Appendix I: Comments and Responses

This appendix provides responses to public and agency comments on the American River Common Features (ARCF), 2016 Flood Risk Management Project Draft Supplemental Environmental Impact Statement/Subsequent Environmental Report (SEIS/SEIR) received during the public comment period for the Draft SEIS/SEIR.

Figure 9. ARMS One Inlet Backwater Concept

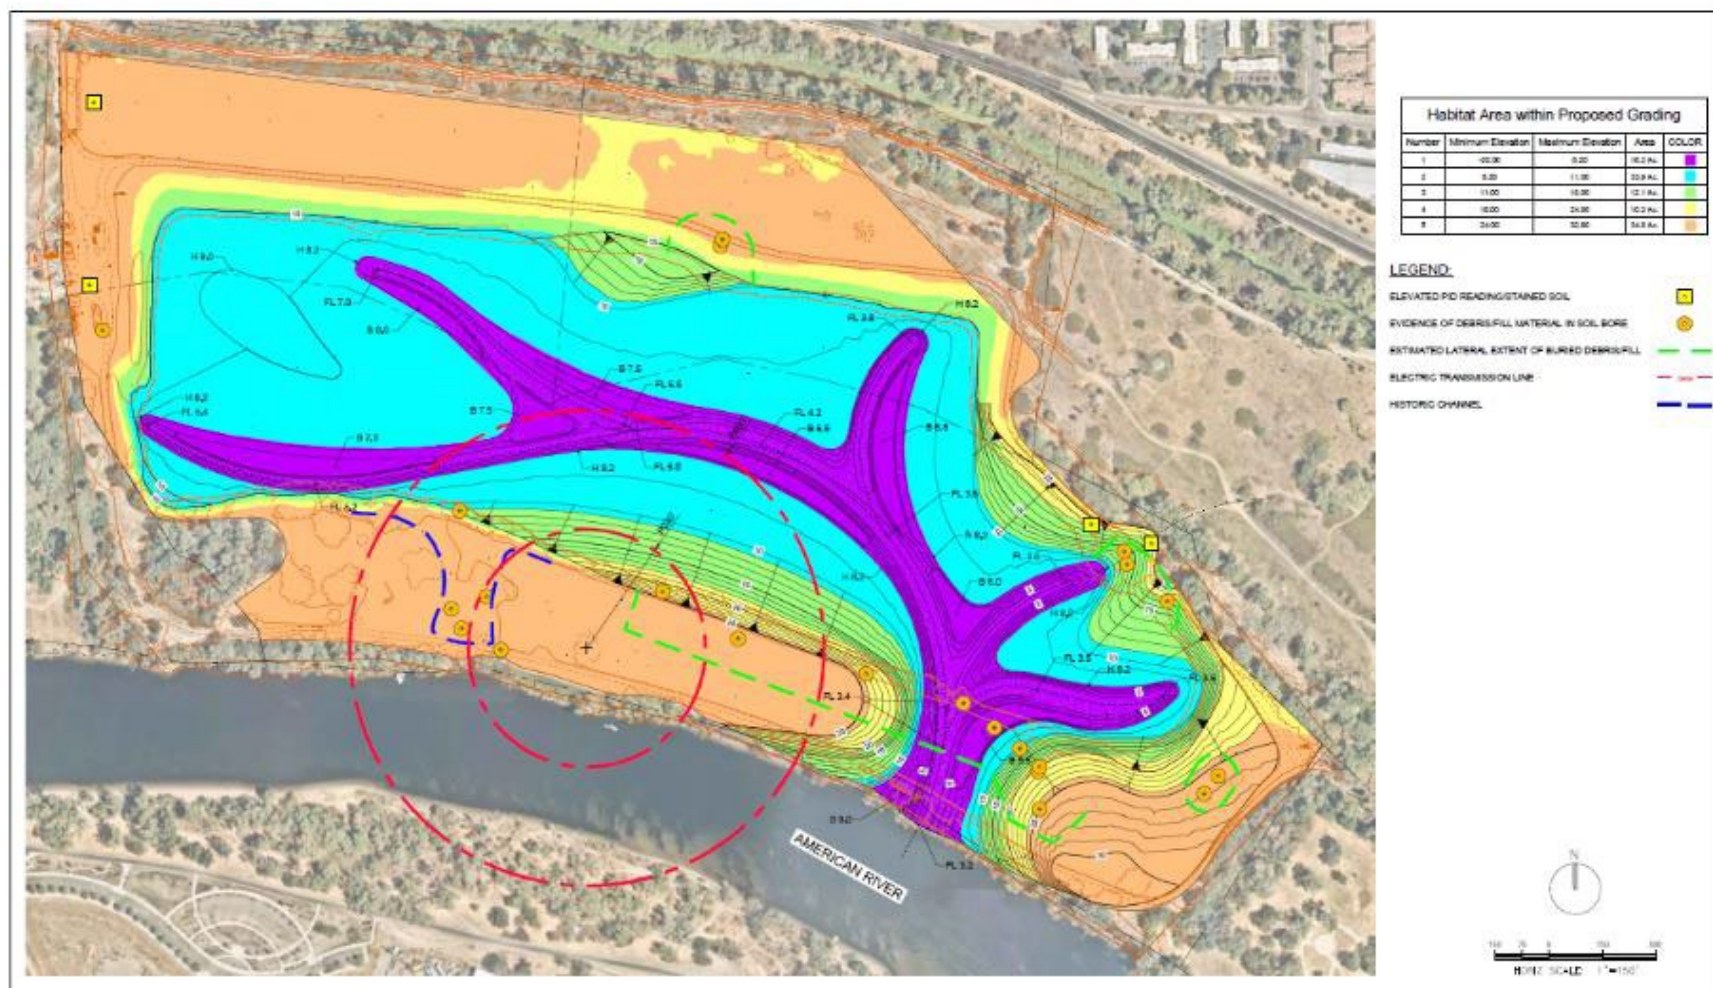
Retention of a portion of the pond post-project would maintain a stranding risk for salmonids, as well as create preferred habitat conditions (i.e., slow flowing, deep water) for non-native predatory fishes that negatively impact native salmonid populations. In addition, the portion of the pond remaining would need to have the existing debris and materials capped to address any public health and safety concerns associated with potential post-project recreational activities, as well as generate increased long-term maintenance challenges associated with the berm, vegetation removal, sedimentation, and water quality. The concept that proposes to restore the entire pond to riverine and riparian habitat generates the needed compensatory mitigation acreages, has the greatest minimization of salmonid stranding risk, maximizes habitat value for

special-status species, and aligns with the Parkway Plan and NRMP. Therefore, the project design team removed the concept retaining the pond from further consideration because it did not meet the project objectives.

Figure 12. Anticipated Post-Construction Hydrograph

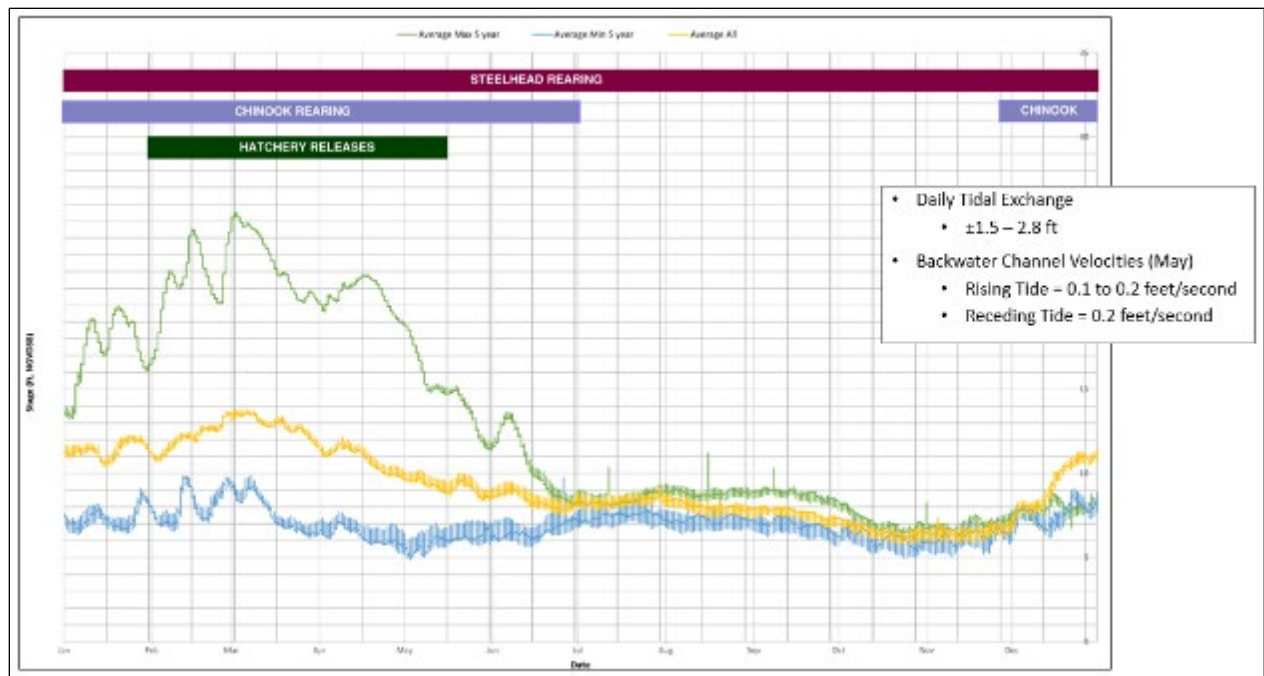
Figure 12 shows the anticipated post-construction hydrograph based on 20 years of WSE data in which all data were analyzed to create an average stage elevation curve, for comparison with an average of the highest 5 years of stage data and the lowest 5 years to generate curves for high and low water conditions. As can be seen in Figure 12, the average annual high-water elevation is 15 feet NAVD 88, which would typically occur in March, and an average low between 6 feet and 7 feet NAVD 88 from mid-October to early December, at which point the WSE would begin to rise. Depths of 0 to 20 feet and velocities of 0 to 0.2 feet/second were calculated by the hydraulic model throughout the backwater channel for likely flow of 3,900 cubic feet per second and stages 4.6 feet to 23.72 feet. Daily tidal exchange ranges are also estimated at 1.5 to 2.8 feet. These data, along with reference site observations, were used to inform the design elevations and habitat zones.

Because of the highly variable nature of the anticipated post-construction WSEs, available and suitable salmonid habitat would only represent a fraction of the inundated extents in any given month, because shallow water habitats would be transitory as the WSEs ascend and descend throughout the year. Figure 13 through Figure 18 show the anticipated lateral extent of inundation in plan view and cross section. These figures were adapted from a presentation given by the USACE design team to the LAR Task Force on December 12, 2023¹⁹. Figure 19 through Figure 24 provide a series of 3D visual renderings of the anticipated 20-year post-construction condition, when riparian woodland canopy would be fully developed. The target percent cover of woody vegetation in these zones is in draft and still being discussed and evaluated. In a meeting on December 6, 2023, with representatives from USFWS, NMFS, National Park Service (NPS), and Regional Parks it was requested that the target percent cover of woody vegetation be increased to 70 percent cover; as a result, target percent cover standards per habitat zone would be refined as the design progresses.

Figure 31. Contract 4B trees under evaluation within Segments 3-8 and 4-1

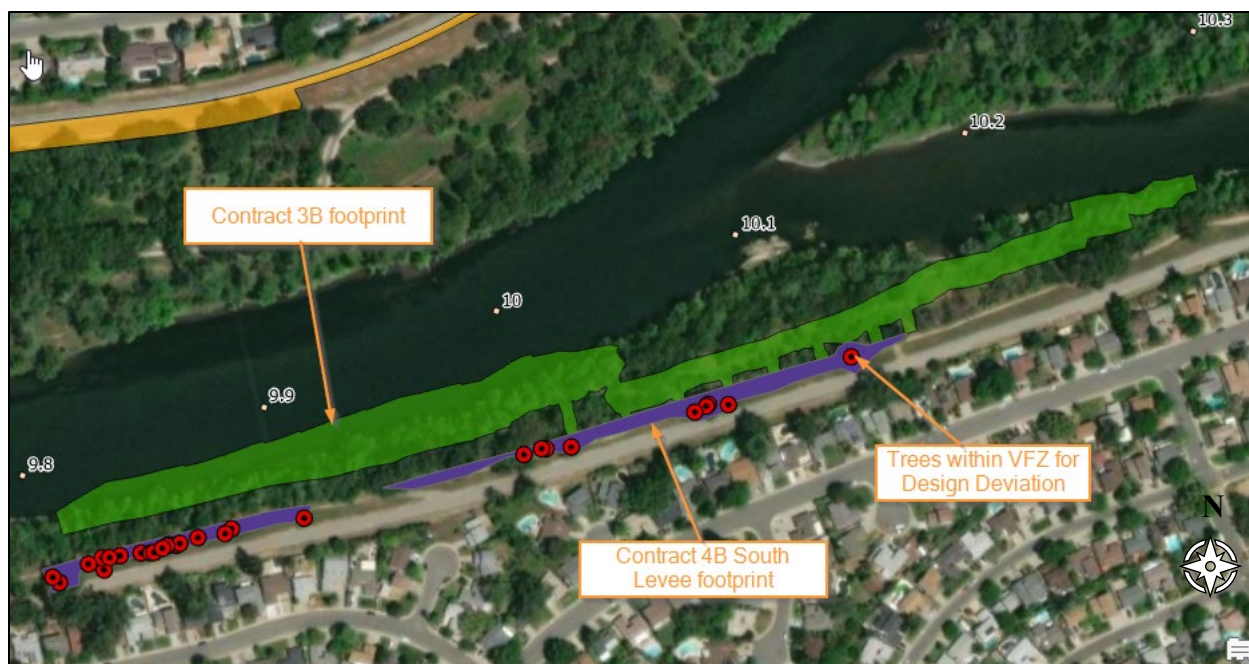
Step 1: Identify individual trees in close proximity to the levee which may threaten the levee if scour were to occur. USACE completed an initial assessment and identified 81 trees for study. These trees include all trees located on the waterside slope of the levee and within 25 feet of the waterside levee toe. Figure 30 and Figure 31 show the locations of these 81 trees.

Figure 32. Contract 3B Tiebacks

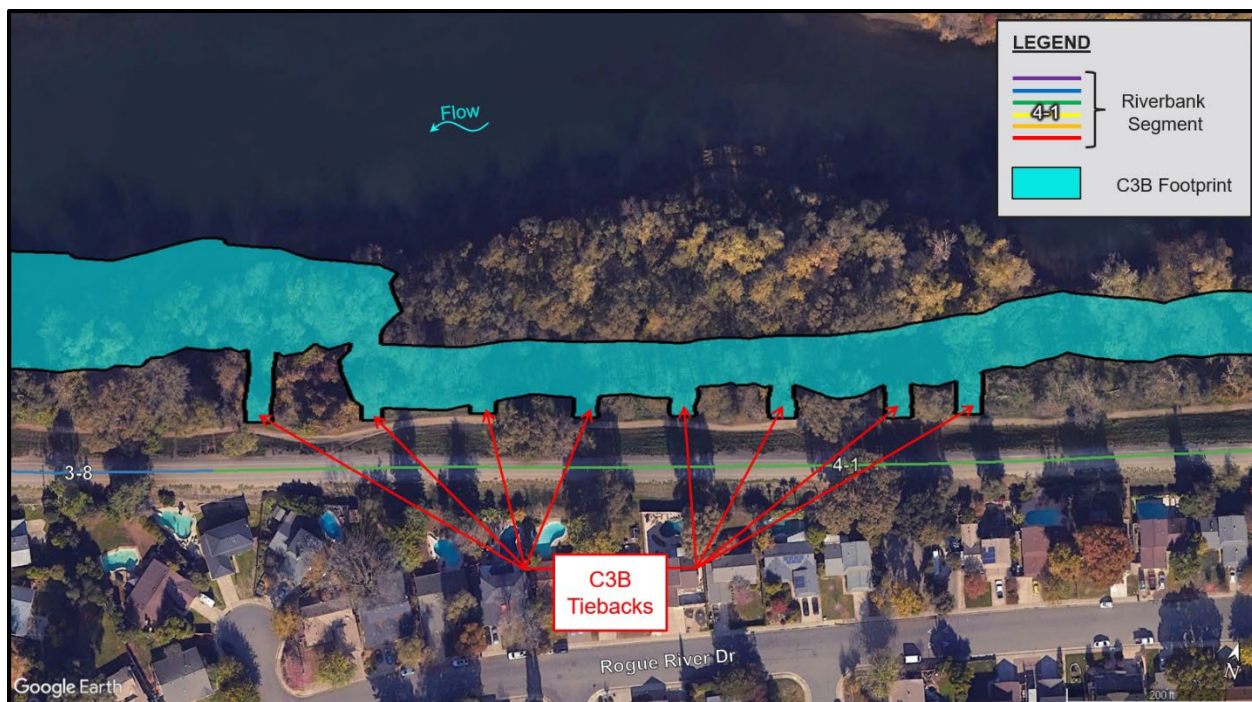
Within Contract 3B Segment 4-1 on the south bank of LAR, upstream of Watt Avenue, part of the erosion protection planned includes installation of rock tiebacks which serve to prevent erosion from outflanking the revetment installed at the riverbank's edge (i.e., eroding the bank/levee landward of the riverbank's edge revetment). These tiebacks can be seen in Figure 32 below. The locations of these tiebacks were selected to avoid impacts to existing vegetation and were intended to extend further landward into the VFZ to ensure the tiebacks ability to prevent erosion from outflanking the Contract 3B bank revetement; however, due to concerns which arose late in the design development phase of Contract 3B the tiebacks were cut short to avoid encroaching into the vegetation free zone. The concerns were specific to working in and around the vegetation which exists within the VFZ which could trigger the need for, and USACEHQ approval of, a VDD. Given the time requirements to develop and get approval of a VDD, as further described in Section 2.4 above, it was decided to stop the Contract 3B tiebacks outside the VFZ and construct the remaining extent of the tiebacks under Contract 4B which was already planning on developing a VDD to support preservation of trees identified as a lone tree scour risk described in Section 2.

Figure 33. Rock Tieback Typical Cross Section

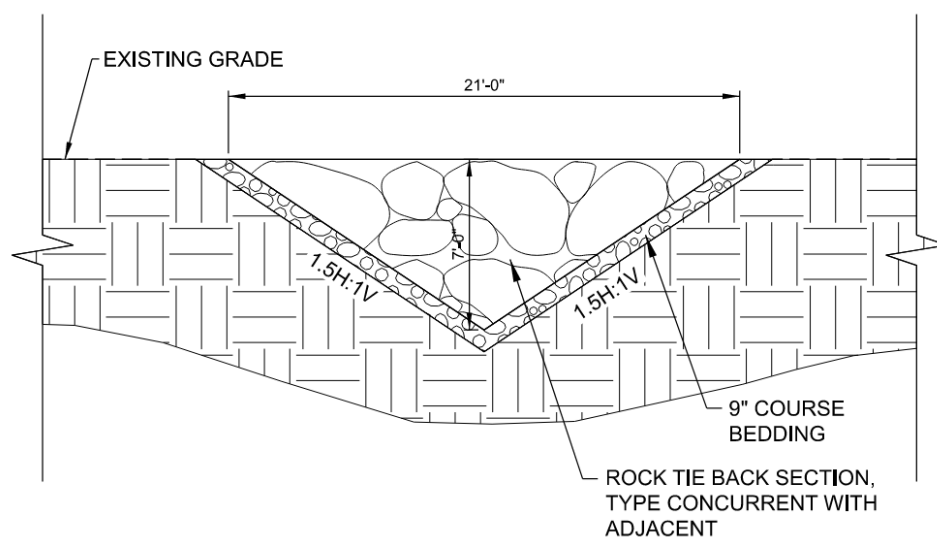
The Contract 3B tiebacks are fully buried and constructed using soil filled rock. For Contract 4B, the eight tiebacks depicted in Figure 32 above will be extended further landward and be constructed in the same manner as Contract 3B. The exact length of each tieback extension is still being determined but the tiebacks will extend into the VFZ and into the levee embankment. A typical cross section of the tiebacks is shown in Figure 33 below. A rough estimation of the extended tieback footprints is shown in Figure 34 below.
